Name Of Dam: DOUTHAT DAM

Location: BATH COUNTY, VIRGINIA.

PHASE I INSPECTION REPORT

NATIONAL DAM SAFETY PROGRAM

FIGURE 4

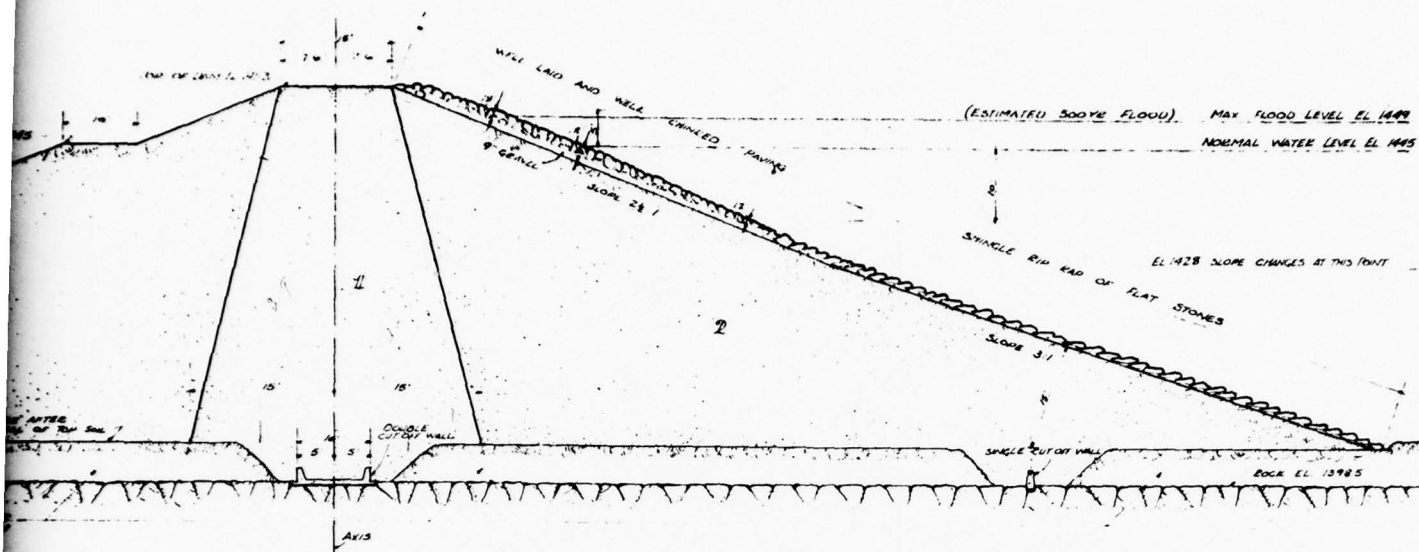
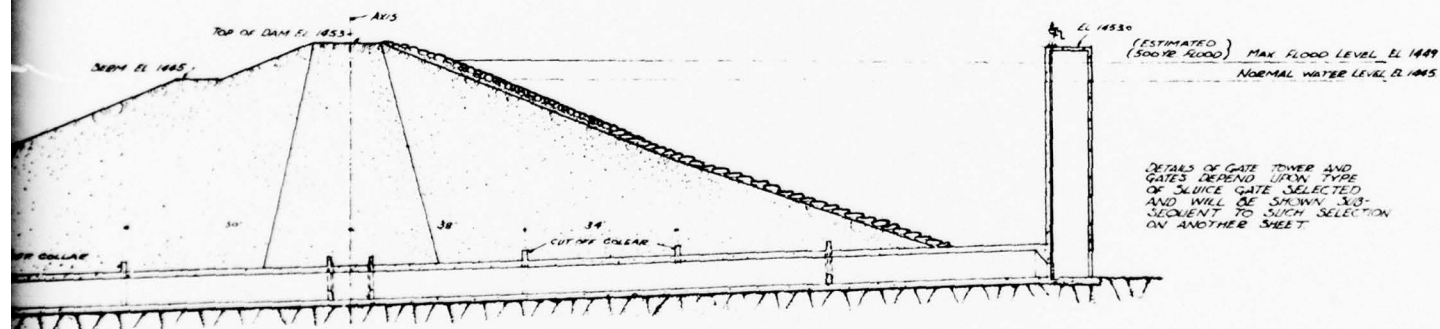
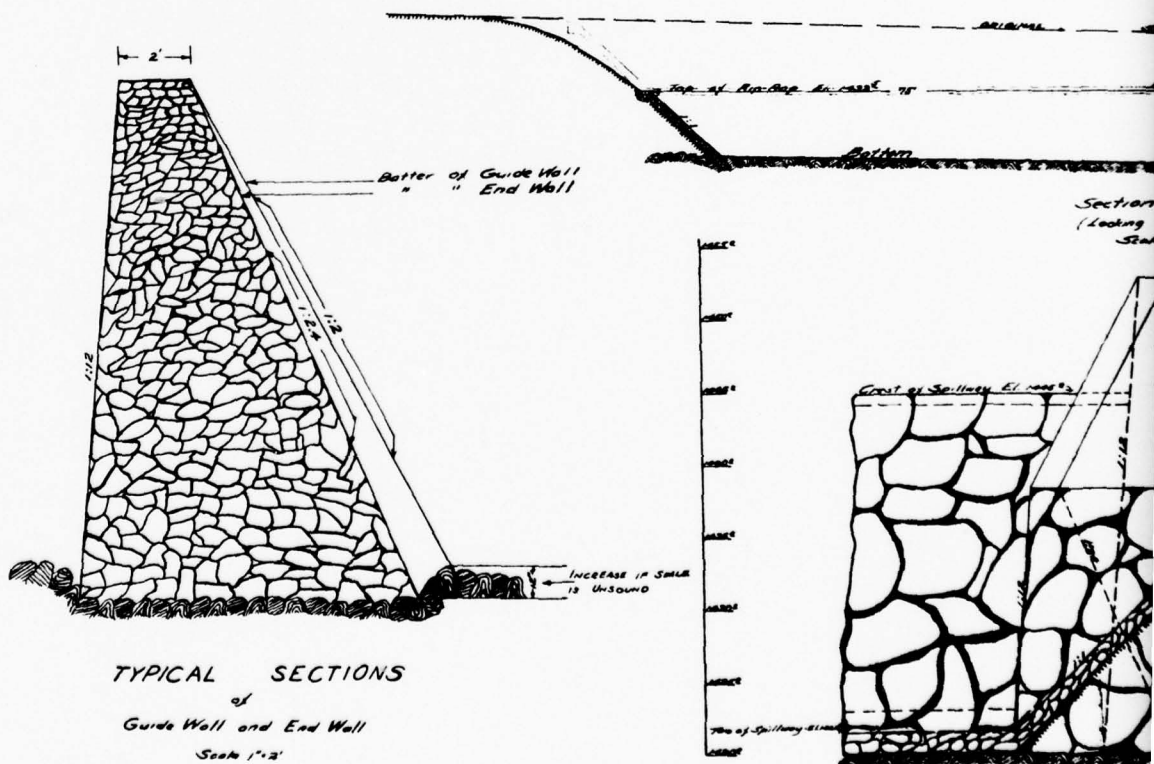
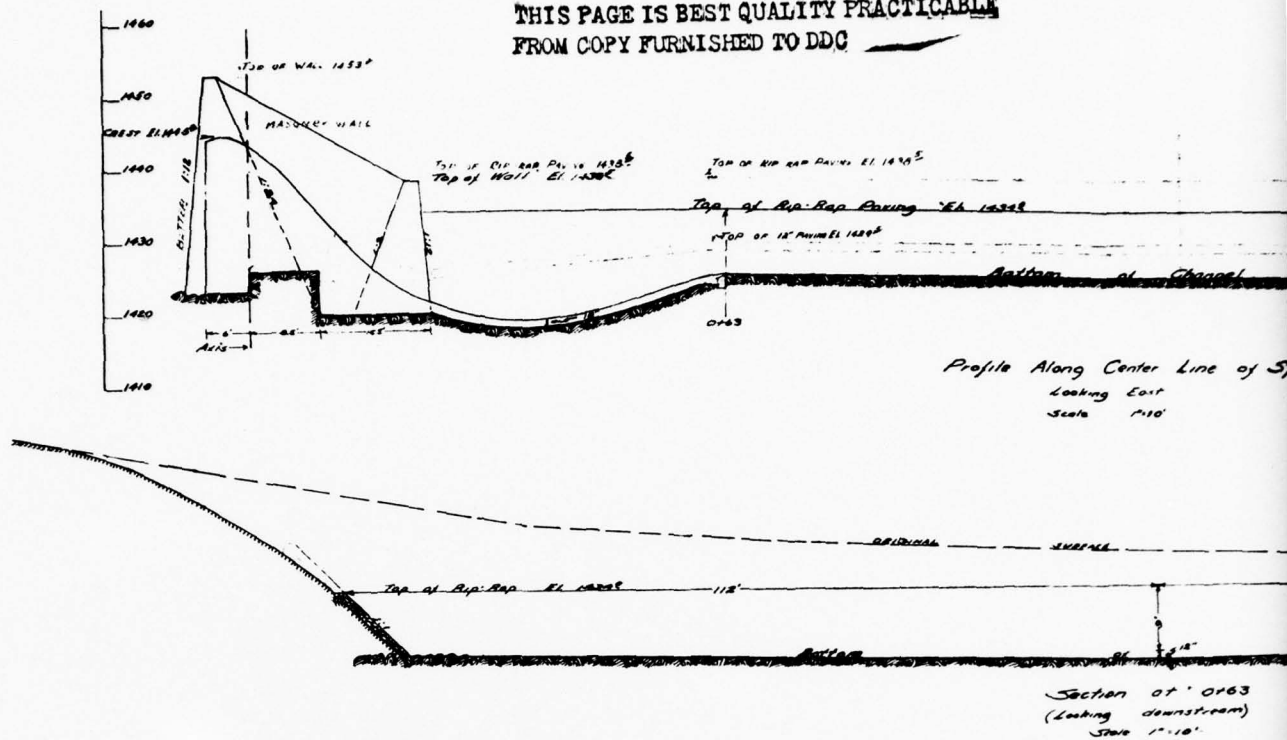
The drawings show that the impervious earth core and the concrete cutoff walls were designed to be founded on bedrock. The site under fill east of line A-B (see Figure 3, Appendix I) was to be stripped to rock. West of line A-B the site was to be stripped of loam only. Line A-B was to be located in the field where soil ceases to show reworked alluvial deposits, such as loam, silt, and sand deposits. The foundation for earthfill at the cliff near the east end of the dam was to be stepped to provide a more stable base for the fill.

2.4 Evaluation: There are no foundation exploration and construction data, or design calculations and data available, and the description of the zoned material shown on the design drawing was inadequate to enable a complete evaluation of the dam stability. The spillway channel profile shown in the design drawing is not consistent with what was observed in the field; i.e., a drop at the end of the plunge pool of the spillway was not shown on the design drawings.
